PLAN REVIEW SHEET

Petition: 2013-035

Summit Avenue Freedom Drive LLC Email: bhorton@charlottenc.gov

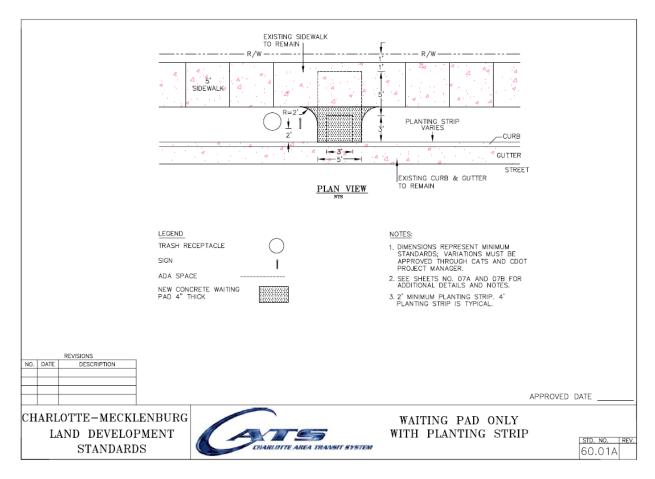
We request that the Petitioner provide a waiting pad for bus service along West Morehead Street. The pad may be located where a driveway is requested by CDOT to be closed.

The size and specification of the concrete waiting pad at the bus stop would be located between the existing curb and the existing sidewalk and be 5 feet in width. Pad must be flush with sidewalk and level within 2% when measured perpendicular to street for compliance with the ADA. Below is an image of the standard (CLDSM – 60.01A) waiting pad.
